STAFF RECOMMENDATION
1803 Cedar Lane
November 19, 2018

Application: New Construction - Addition
District: Belmont-Hillsboro Neighborhood Conservation Zoning Overlay
Council District: 18
Map and Parcel Number: 11704032600
Applicant: Van Pond, Architect
Project Lead: Sean Alexander, sean.alexander@nashville.gov

EXTENSIONS + RENOVATIONS TO:
1803 CEDAR LANE
NASHVILLE, TENNESSEE

METRO HISTORIC ZONING COMMISSION SUBMITTAL

Proposed Site Plan
 SURVEY INFORMATION PROVIDED BY:
 CLARK SURVEY GROUP
 10711 WATTS STREET
 NASHVILLE, TN 37203
 615.214.7000
 DATED: JUNE 18, 2018

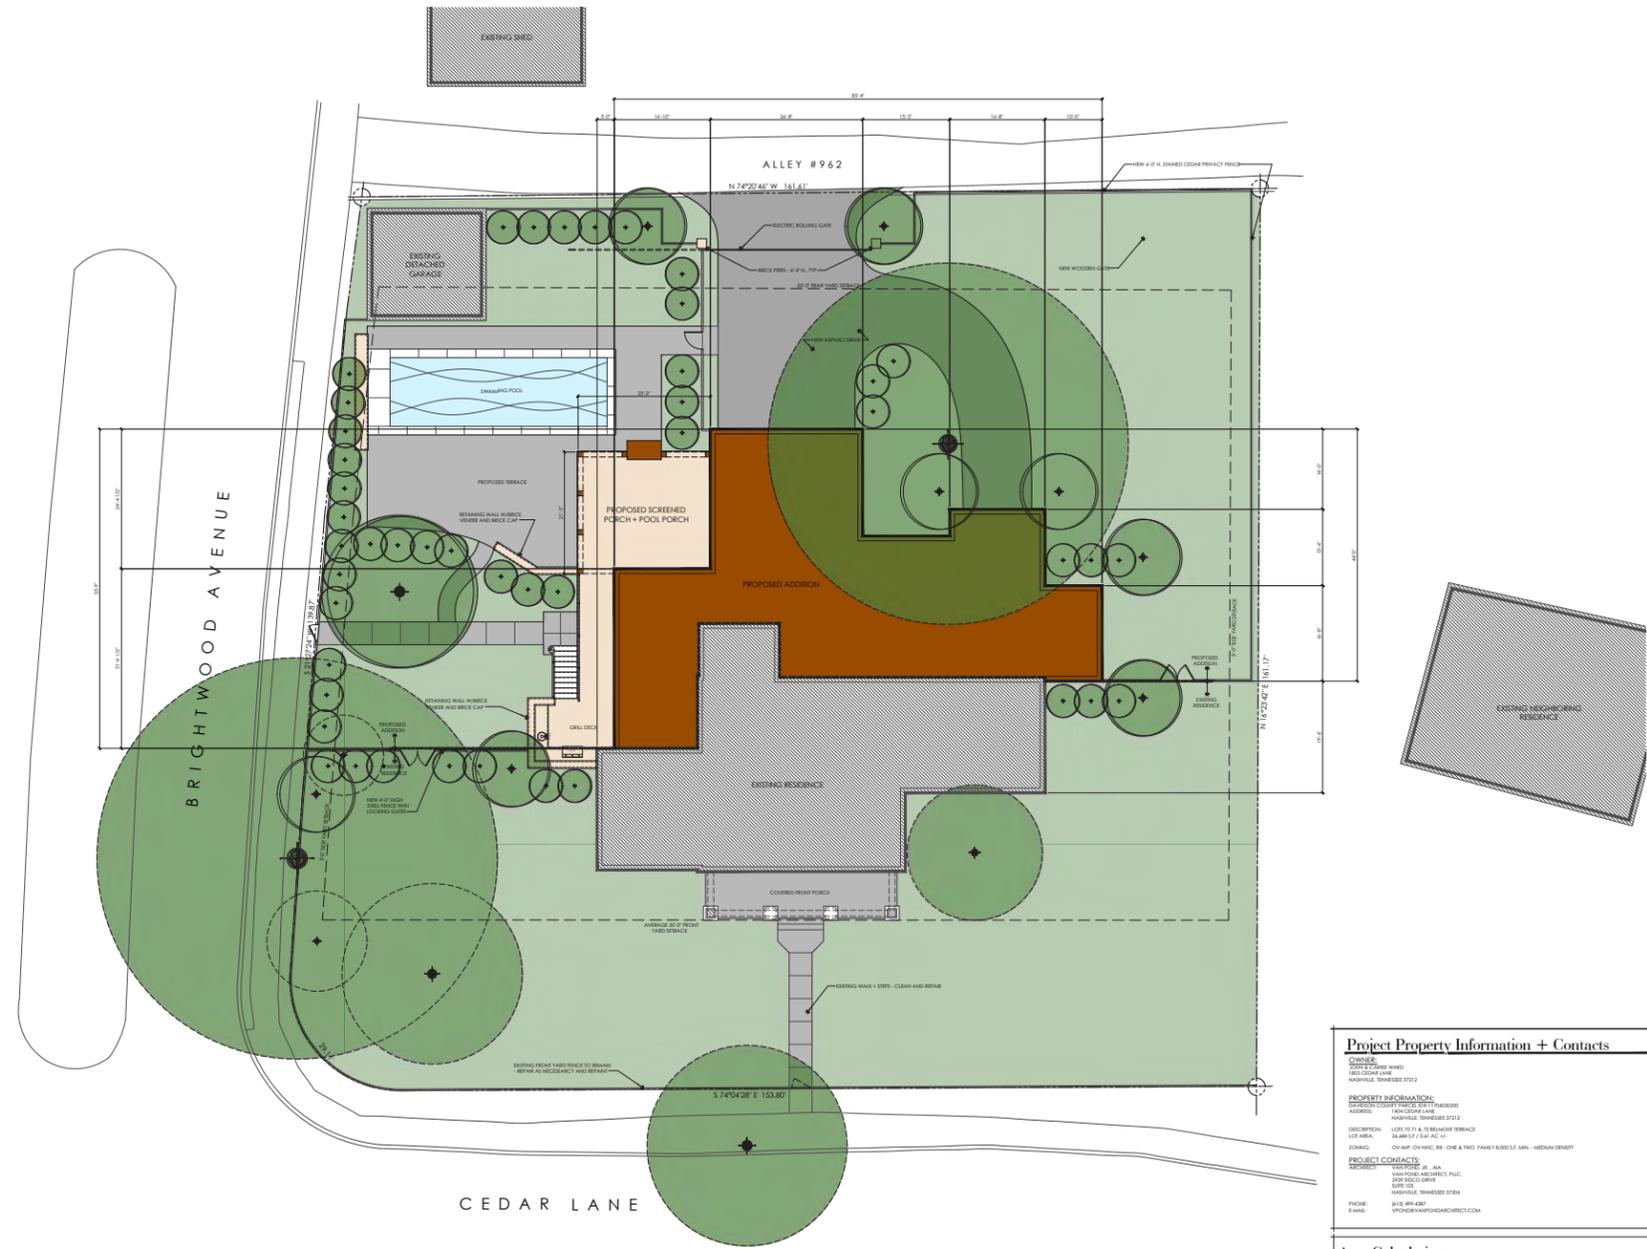
Height & Scale: The two-story component of the addition will be stepped in two feet (2') from the sides of the historic house and extend sixteen feet (16') to the rear before stepping in five feet (5') further on the right side and continuing another twenty-nine feet (29') back. The addition will have a hipped roof with the ridge six inches (6") lower than the original roof's peak.

The one story addition on the left side will step in three feet (3') from the outer wall of the existing addition and extend back thirty feet (3') before stepping out six feet (6') to the left, three feet (3') wider than the existing addition. On the right side the addition will originate at the rear of the existing addition and extend ten feet (10') to the right and go back fourteen feet (14').

Setback & Rhythm of Spacing: The standard lot width for most of the Belmont-Hillsboro neighborhood is fifty feet (50'), but lots on Cedar Lane are typically sixty-five feet (65') wide or greater. This lot is significantly larger at more than one hundred, fifty feet (150') wide at the front. Although the addition is wider than the house on the left and right, it will meet all of the required setbacks and the effect on the wider-than-average lot will not disrupt the rhythm of spacing on the street.

Appurtenances & Utilities: The proposal indicates that the existing driveway will be altered to access a rear-loaded basement garage, but it will still be at the rear and enter from the alley. This is an appropriate driveway location, and basement-level garages are typical of the area historically on lots where the grade falls to the rear. A terrace and walkway will be added in the rear yard between the house and existing garage. These features do not need to be reviewed in a Neighborhood Conservation Zoning Overlay. The HVAC units are currently located on the rear of the house, and would therefore need to be relocated. Their new location is not indicated, so Staff would suggest that they be behind the midpoint of the building in order to meet Section II.B.1.h of the design guidelines.

1. Staff shall approve the window and door selections;
2. Staff shall approve the roof color; and,
3. The HVAC units shall be located behind the midpoint of the building.
